Permit No: PRRES20231491
Plan Name:
Project Address: 1524 NE PARK SPRINGS TER, LEES SUMMIT, MO 64064
Parcel Number: 284214
Location: PARK RIDGE 8TH PLAT LOTS 362-391 --- LOT 391

Our firm has been asked to make structural clarifications to the plans of the house to be built at the address listed above. During the permit review process the AHJ has questioned items. Below is a list of our recommendations along with the corresponding city item.

STRUCTURAL REVIEW
HD ENGINEERING & DESIGN
HD: 44934 DATE: 11/21/2022

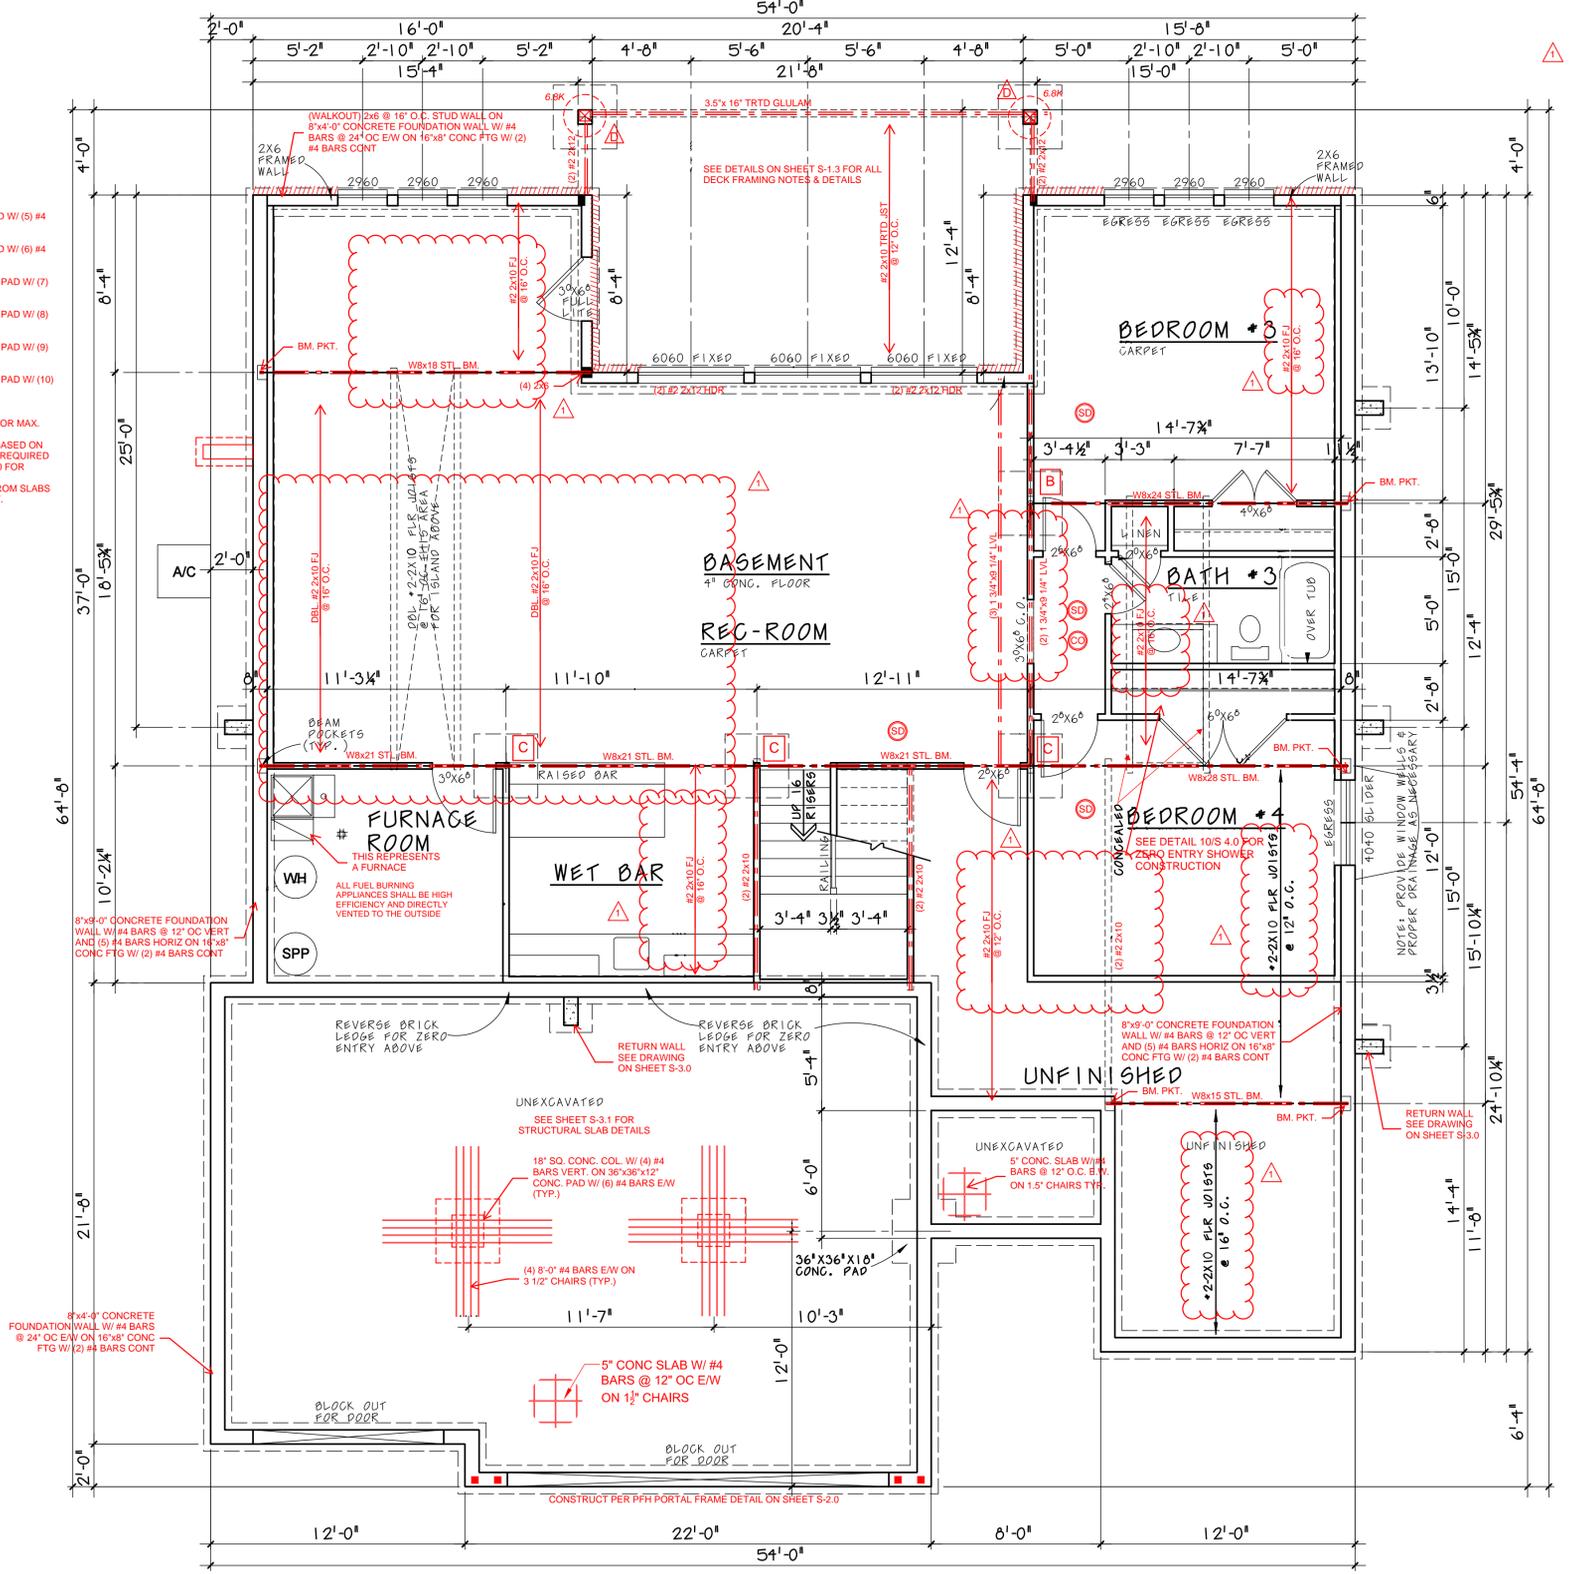
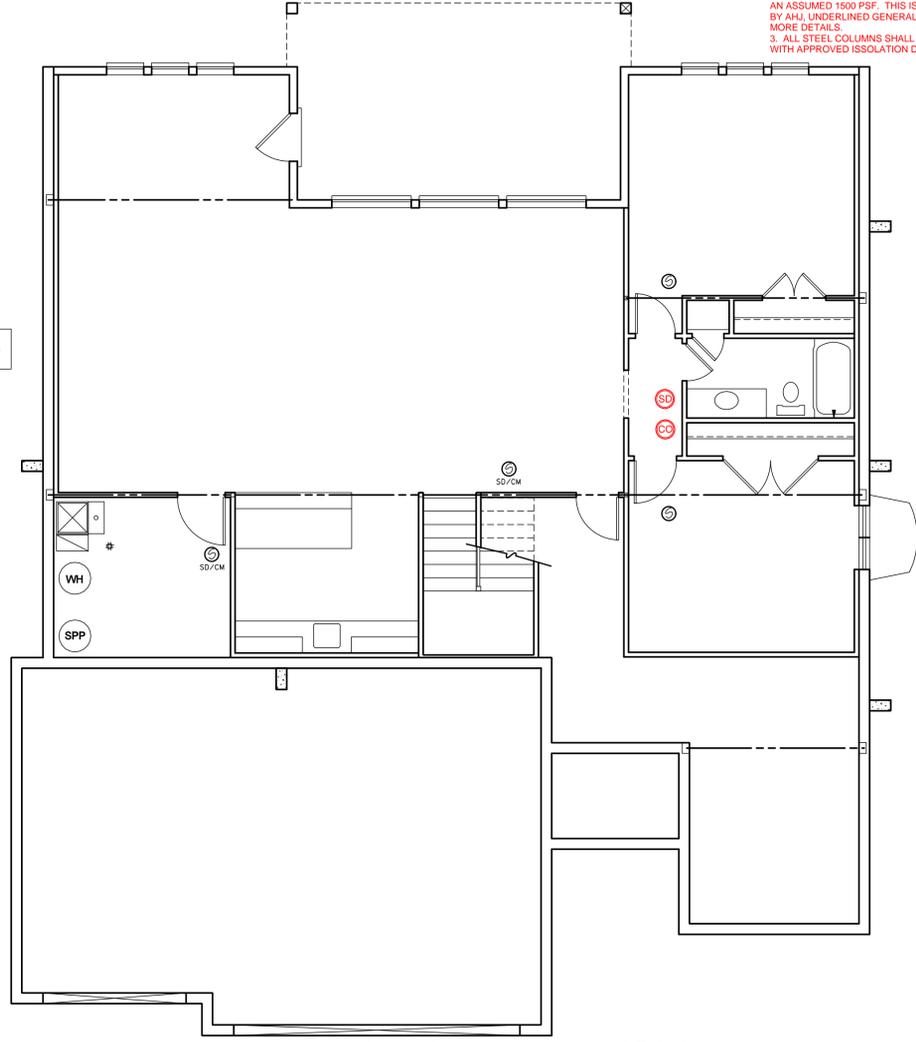
2. Identify emergency escape openings from bedrooms and basement(s). (IRC Section R310 as amended per Ordinance)

LABEL BEDROOM 2 EGRESS WINDOW **SEE ATTACHED PLANS.**

3. Designate locations of smoke detectors and carbon monoxide detectors. (IRC Section R314 and R315)

BEDROOM 3 AND 4 NEED SMOKE DETECTORS INSIDE BEDROOMS (MARKED IN ONE DRAWING BUT NOT THE OTHER).
BEDROOMS 1, 2, 3, AND 4 NEED COMBINATION SD/CM DETECTORS IMMEDIATELY OUTSIDE. **SEE ATTACHED PLANS.**

MAIN FLOOR PLAN

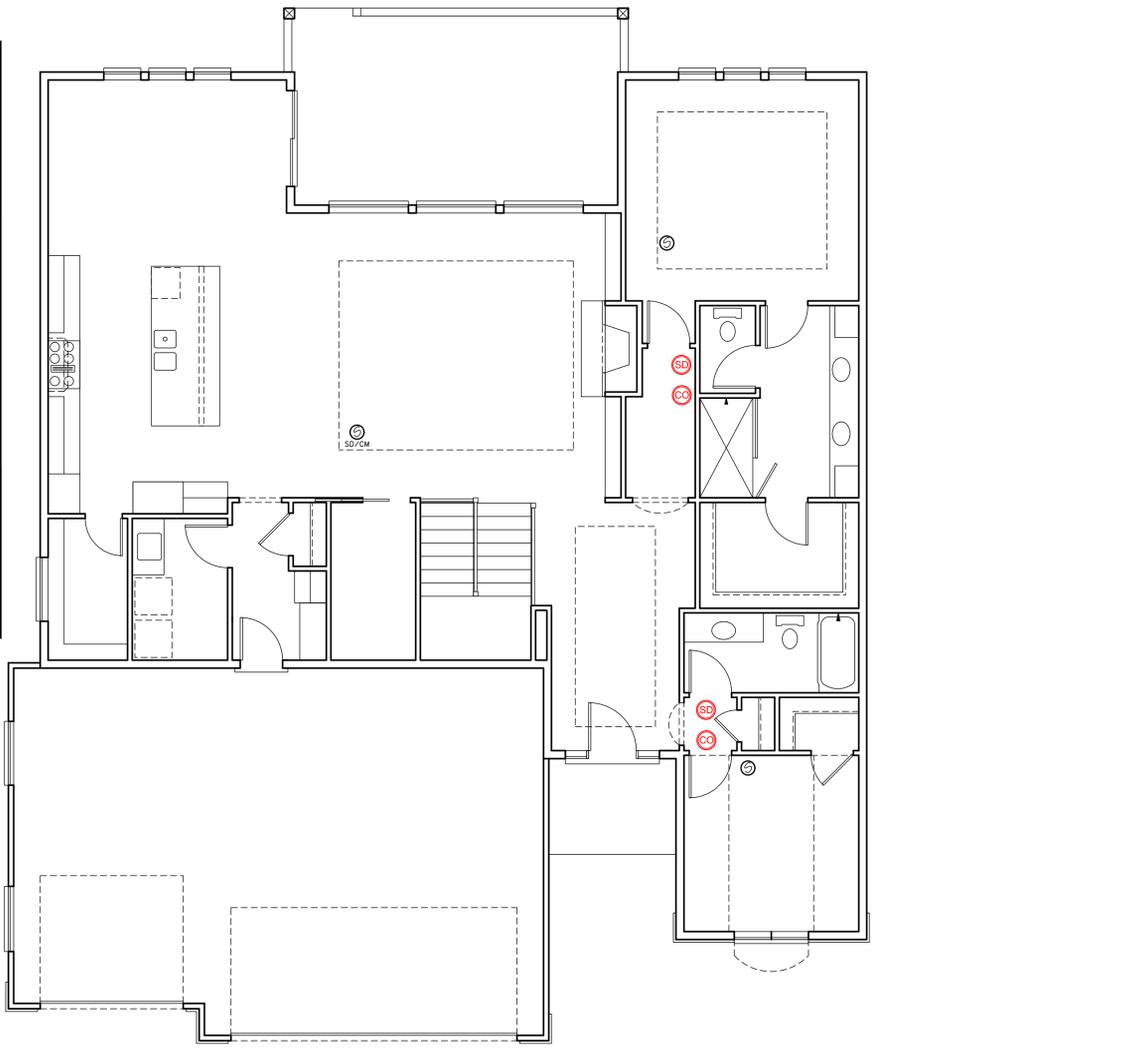
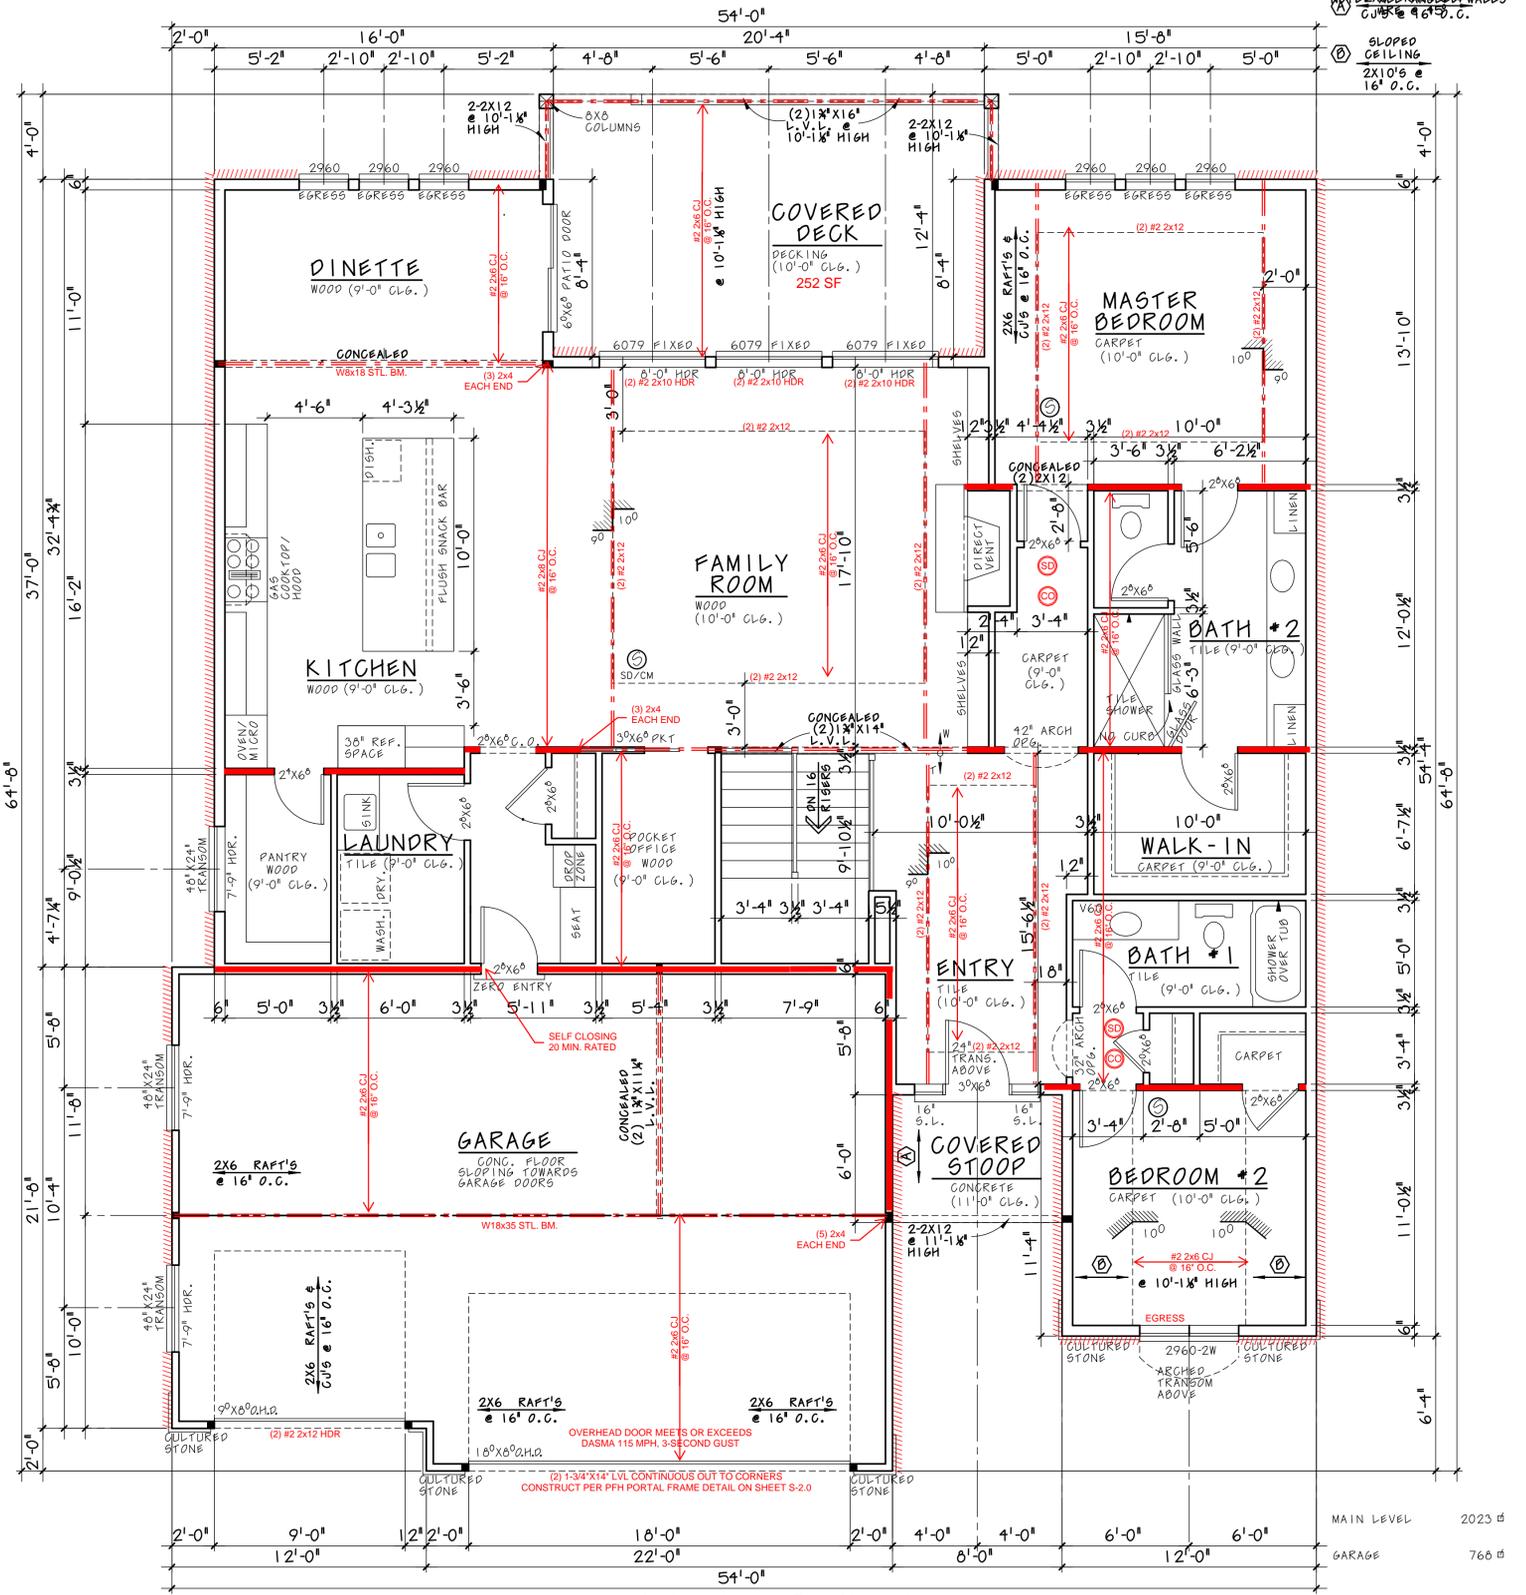
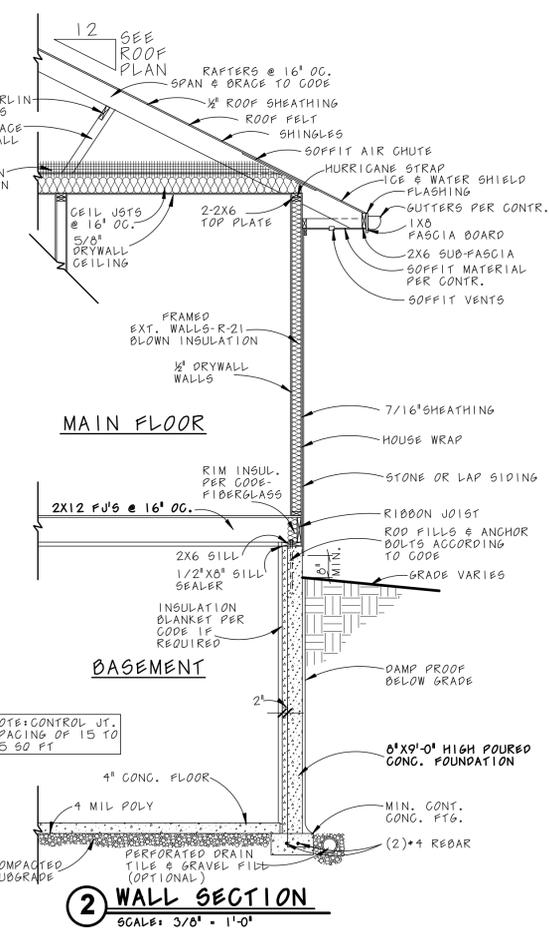
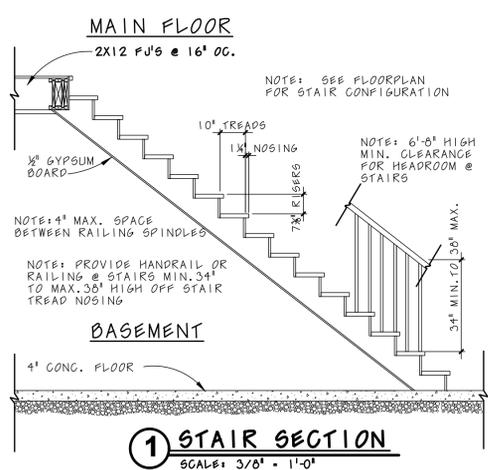
6. Detail required separation between garage and living area including door, door closer and gypsum board. (IRC R302.5)

PLEASE LABEL DOOR AND DOOR CLOSER. **SEE ATTACHED PLAN AND NOTES ON S-1.0.**

11. Identify braced wall locations and length of braced wall panel(s). (IRC Section R602.10) **SEE ATTACHED PLAN.**

12. Identify interior load bearing walls. (IRC Section R602) **SEE ATTACHED PLAN.**

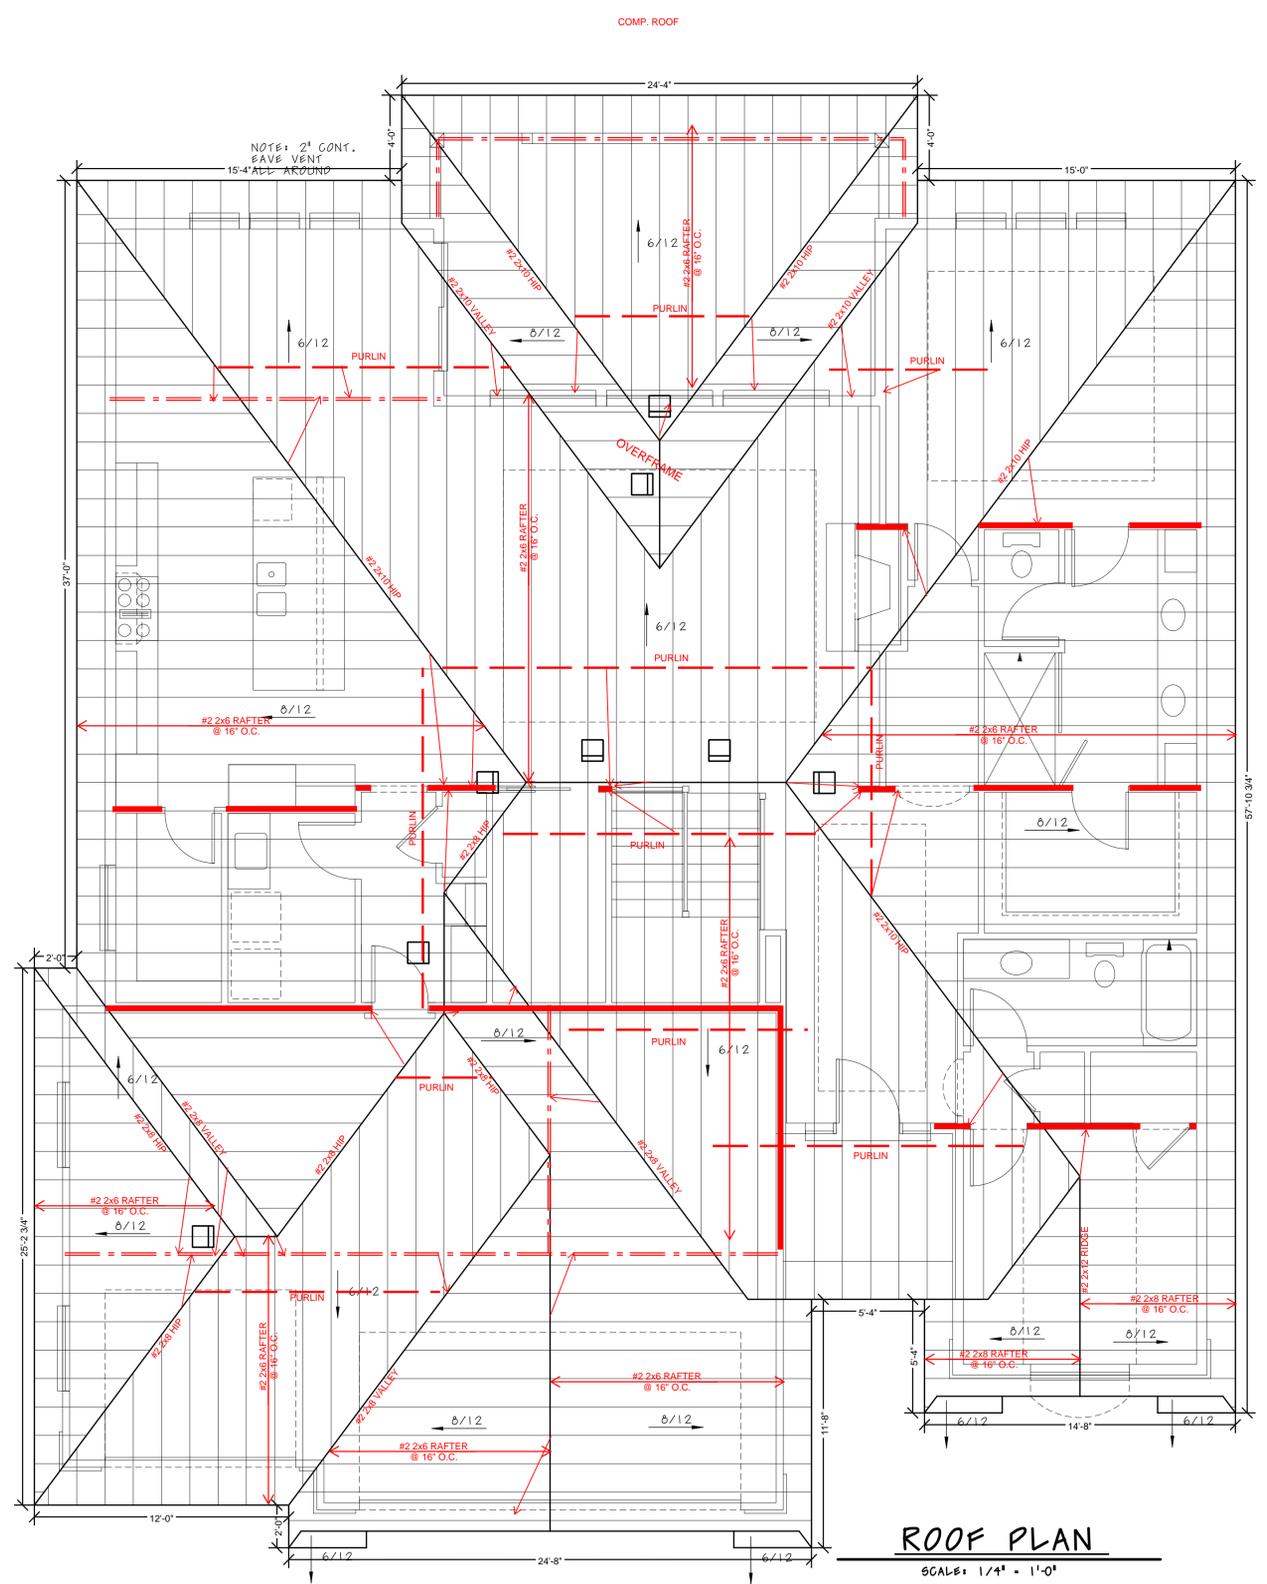
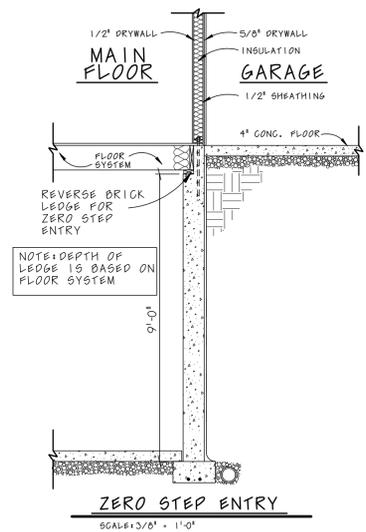
7. Identify roof covering material (IRC Section R905) **SEE ATTACHED ROOF PLAN.**

8. Specification of rafter ties or ridge beam design. (IRC Section 802.5.2) **SEE ATTACHED ROOF PLAN AND SHEET S-1.0.**
